Petition To Tim Price of VicRoads

Please build the Drysdale Bypass without 3 new signalized intersections (and one roundabout) at the western entrance to Drysdale and NOT as shown: -

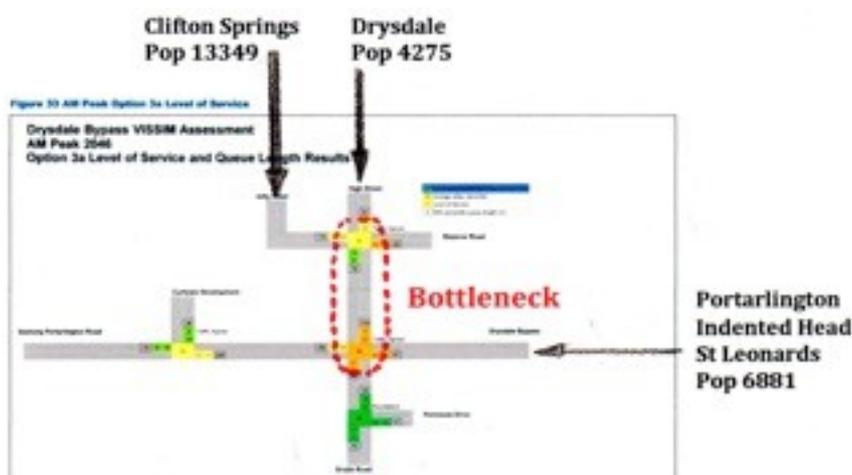
If the traffic infrastructure is built as currently proposed: -

1. **There will be an excessive number of vehicle-to-vehicle, vehicle-to-cyclist and vehicle-to-pedestrian conflict points** where vehicles are allowed to travel along conflicting paths at impact speeds higher than those regarded as thresholds of severe injury. This does not comply with Victoria's Towards Zero Safe Roads System.
2. The risk of Fatal or Serious Injury (FSI) **vehicle-to-vehicle crashes will be increased approximately twenty fold.**
3. The risk of FSI **vehicle-to-cyclist crashes will be increased approximately two fold.**
4. The risk of FSI **vehicle-to-pedestrian crashes will be increased approximately two fold.**

5. **Option 3a creates a traffic bottleneck that VicRoads data shows is a massive 10 times less traffic efficient than option 11 for Clifton Springs Drysdale traffic and a massive 5 times less traffic efficient overall.**

Please build Option 11 and (instead of the N/S connector) upgrade the uncontrolled intersection at Hermsley Road to a well-designed roundabout.

Figure 51 AM Peak Option 11a Level of Service

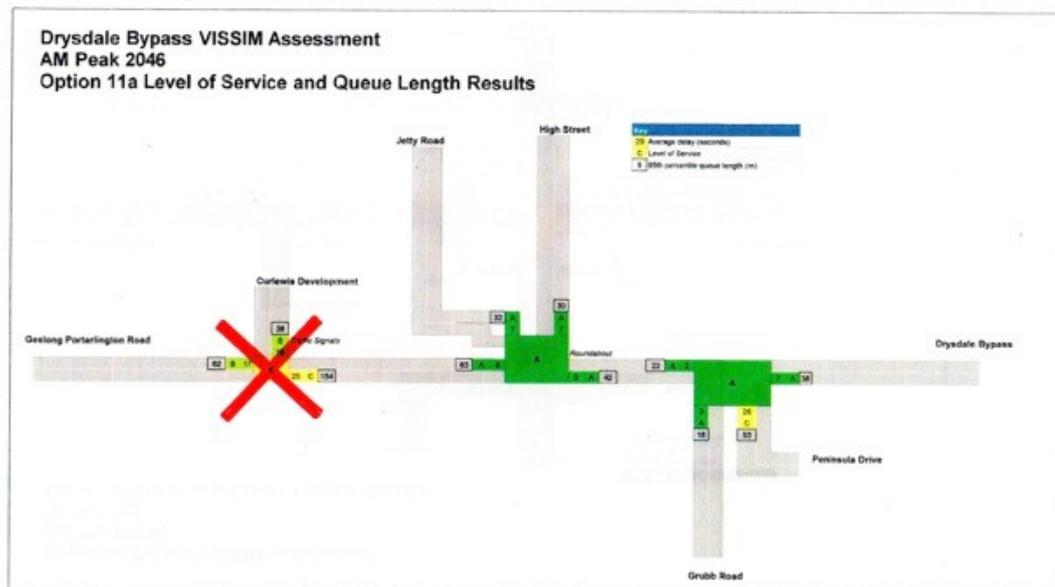
VicRoads own analysis shows that the alternative proposal is much more traffic efficient.

The alternative proposal is a simple improvement of the existing situation where Andersons Road becomes the bypass. The current roundabout is enlarged to two access and two circulating lanes, which overcomes the congestion during peak periods. A 2-lane roundabout replaces the currently problematic, Grubb Rd/Andersons Rd and Peninsula Dr/Andersons Rd intersections. Well-designed slip lanes are provided to Jetty Road and so that Geelong/Bypass traffic only has to pass through one of the roundabouts. VicRoads does not dispute that its own data shows this option 11 is a massive five times more efficient than option 3a for all traffic routes.

Safe pedestrian crossings will be provided across Jetty Road and High Street close to the existing bus stops as shown, an appropriate distance away from the roundabout. The unused section of Grubb Road could become part of the active transport system.
